Subject: FW: Moresby Parks development , minor plan updates.
Attachments: c 6972-100J Road Layout (2).pdf; c 6972-01D Site Layout (1).pdf

From: Mike Rae <raemoredev@aol.com>
To: Christopher Harrison <Christopher.Harrison@copeland.gov.uk>
Subject: Moresby Parks development , minor plan updates.

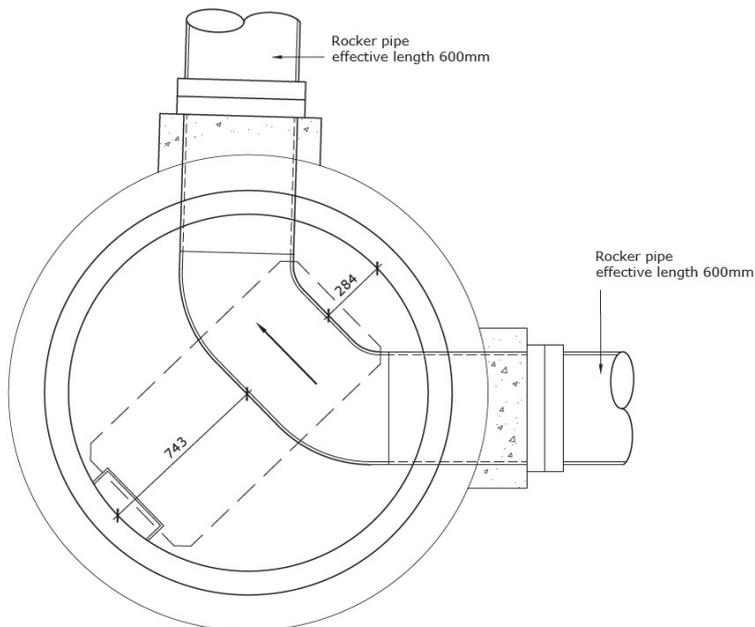
.For the 450mm pipe we would propose to use radius bends, but instead of a 90 degree we would use 2 x 45 bends with a small straight between them, similar to MH-S5 on drawing 6972/206 which I have added a screenshot of below.
